Request - Amendment to a Special Use Permit for a gas station expansion

Location - 4486 Monroe Street

REF: SUP25-0048. . . January 15, 2026

SPECIAL USE PERMIT  
TOLEDO CITY PLAN COMMISSION  
REF: SUP25-0048  
DATE: January 15, 2026  
TIME: 2:00 P.M.

# SITE PLAN

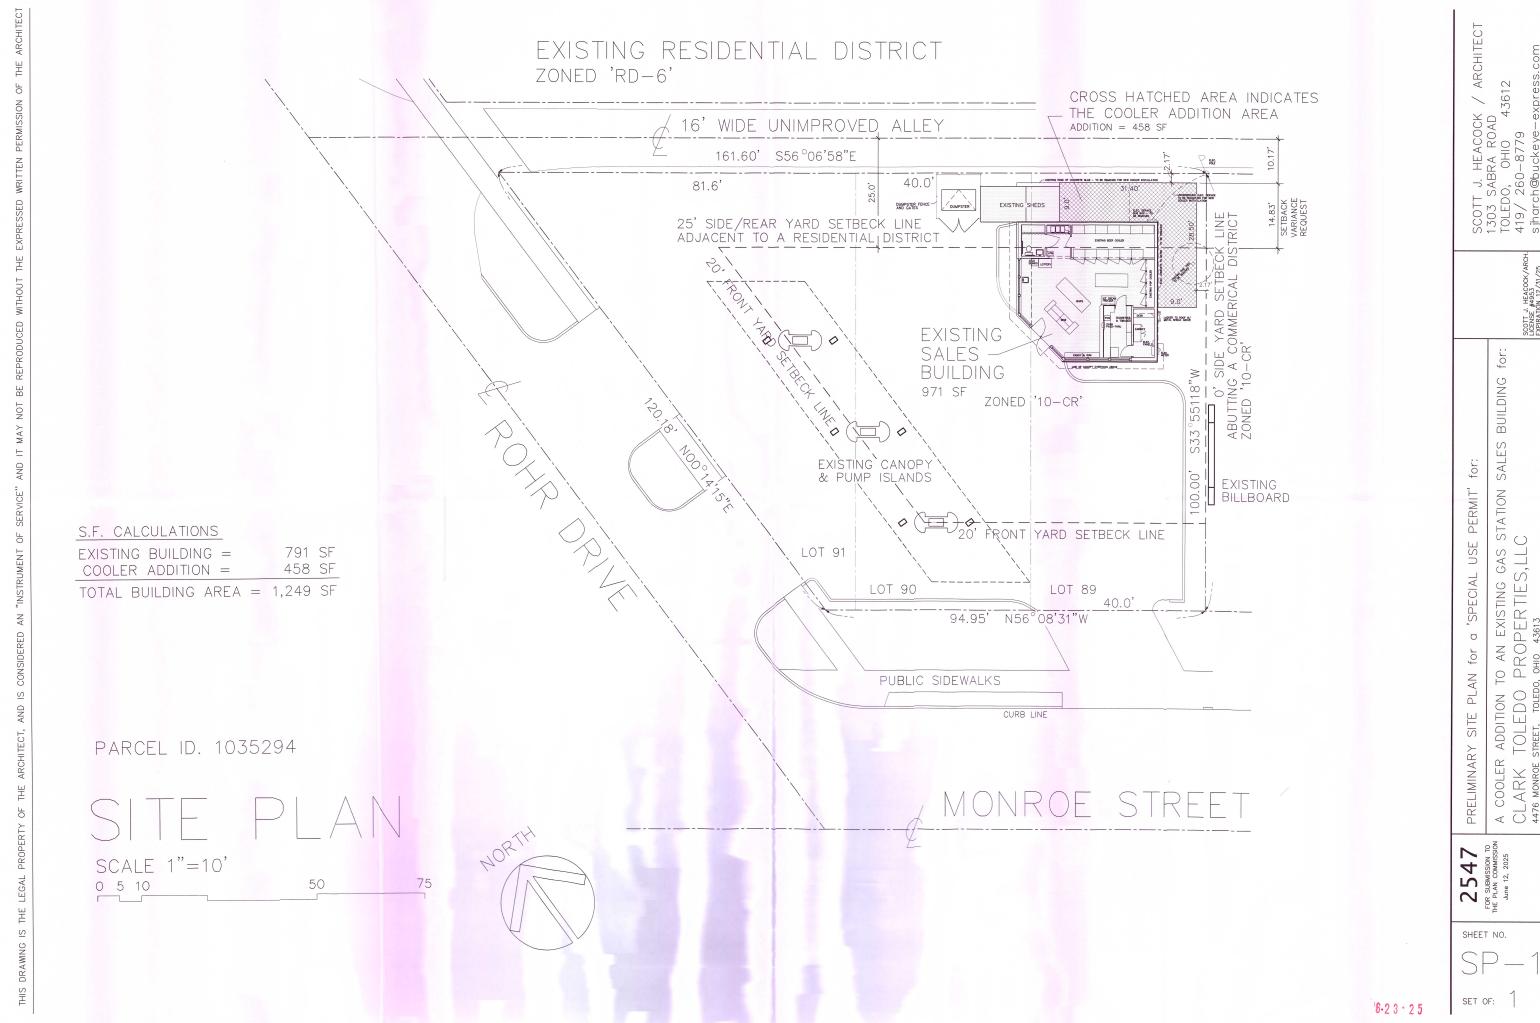
The proposed expansion would not affect or change the site's current parking and circulation pattern; however, a comparison between this pattern and the most recently approved site plan (SUP-74-89) reveals concerns that must be addressed. These concerns were noted by a Zoning Compliance Specialist, who inspected the site on December 10, 225. The SUP-74-89 site plan marked with concerns and violations has been attached as Exhibit "A". The inspection report is attached as Exhibit "B".

Parking spaces on the site are currently not striped. This has led to an irregular parking pattern, including vehicles parking parallel to the structure on its south side instead of perpendicular as approved in the 1989 site plan. The Division of Traffic Management has concerns that this parking pattern could lead to a blockage of the Monroe Street entrance. Considering the proposed site plan does not show parking, a condition of approval has been added ensuring the applicant provide a site plan depicting all drive approaches, parking spaces, drive aisles, and vehicle stacking spaces with dimensions. This revised site plan shall be approved by the Plan Director and Division of Traffic Management.

The Division of Traffic Management has also requested that the applicant close the existing driveway closest to Monroe Street on Rohr Drive. The existing approach and curb would need to be removed with new grass and curb installed to match adjacent areas. The applicant has agreed to close this driveway. It has been listed as a condition of approval.

3. Vehicle stacking at gas pumps must be clearly shown on drawings per TMC 1107.1601.
4. One van accessible parking spot must be clearly shown on drawings per TMC 1107.1701 & 1107.1702.
5. Accessible signage must be posted directly in front of the parking space at a height of no less than 60 inches and no more than 72 inches above pavement level per TMC 1107.1704.
6. All drive approaches, driveways, parking spaces and drive aisles must be clearly dimensioned per TMC 1107.1911. All parking spots must be clearly shown on drawings. **The applicant shall submit a revised site plan to the Plan Director and Division of Traffic Management for review and approval.**
7. The existing driveway closest to Monroe Street on Rohr Drive shall be closed. Existing approach and curb cut shall be removed with new grass and curb installed to match adjacent areas.

8. Free air, water, and restrooms shall be provided and maintained during operating hours of the station per TMC§1104.0903(D).
9. All parking spaces shall be stripped according to a 'final' site plan approved by the Plan Director and Division of Building Inspection.
10. Two (2) bicycle parking spaces shall be provided pursuant to TMC§1107.0900. **A revised site plan shall be submitted to the Plan Director depicting a minimum of two (2) bicycle parking spaces compliant with TMC§1107.0900.**
11. All deficiencies identified by the inspection report dated December 10, 2025 shall be resolved. **A revised site and landscape plan shall be submitted to the Plan Director with all deficiencies resolved.**

## LANDSCAPE PLAN

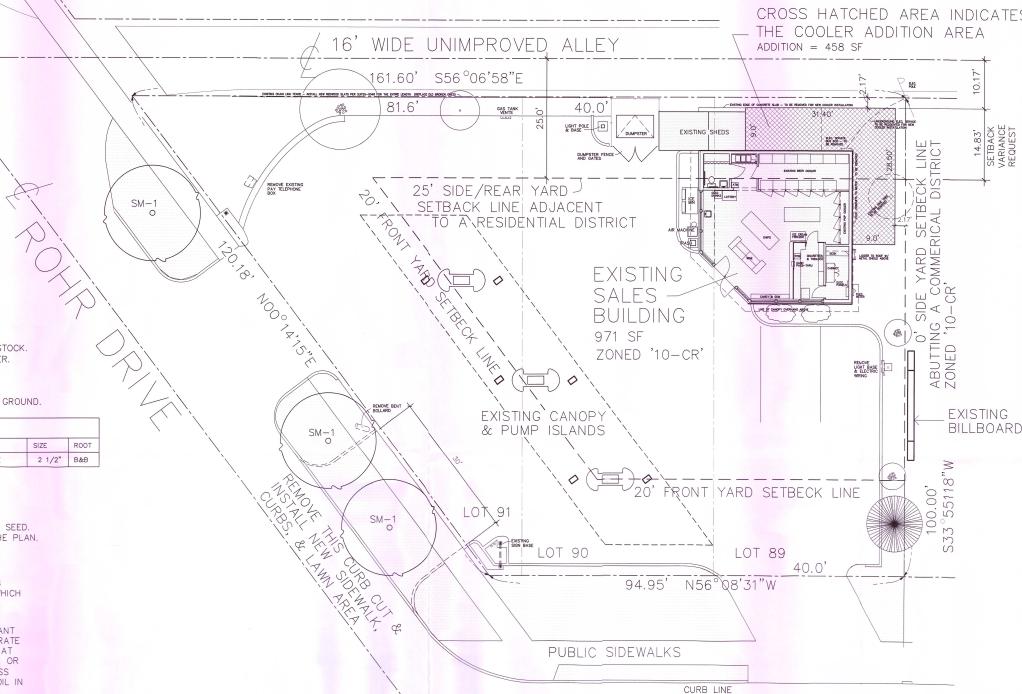
TMC§1106.0102 requires a minimum fifteen foot (15') rear yard setback when abutting a residential district. The property abuts a residential district across a sixteen foot (16') wide alley to the north east. Per TMC§1106.0205(E)(7), one half of the alley may be considered as a portion of the rear yard setback. Including half of the alley the current structure is set back nineteen feet (19') along this abutting property line. The proposed expansion would reduce this setback to ten feet (10'). The applicant has requested a waiver of this setback requirement. Staff is supportive of a waiver of this setback requirement so long as the applicant provides additional landscaping beyond those required by the latest approved landscape plan (SUP-74-89). This is discussed further in the Landscaping section.

Exhibit "A" depicts the site's latest approved landscape plan (SUP-74-89). As discussed, a Zoning Compliance Specialist conducted an inspection on December 10, 2025. This inspection revealed several landscaping deficiencies, which have been listed in Exhibit "B". A condition of approval has been added requiring the applicant to comply with all deficiencies identified in the inspection report.

As a condition of the rear yard setback waiver, the applicant shall install additional landscaping beyond that required by the latest approved landscape plan (SUP-74-89). Staff is requesting that the applicant install landscaping meeting the requirements of frontage greenbelts along both Rohr Street and Monroe Street to the greatest extent practicable. Much of these plantings would need to be placed within the right-of-way. The applicant will therefore be required to obtain encroachment permits for these plantings. Plantings shall be depicted on a revised landscaping plan. This has been included as a condition of approval.

12. Frontage greenbelts meeting the requirements of TMC§1108.0202 shall be installed along Rohr Drive and Monroe Street to the greatest extent practicable. **The applicant shall submit a revised landscape plan to the Plan Director depicting plantings meeting TMC§1108.0202 *Frontage Greenbelt* along both Rohr Drive and Monroe Street to the greatest extent practicable. Applicant shall obtain an encroachment permit for plantings within the right-of-way.**
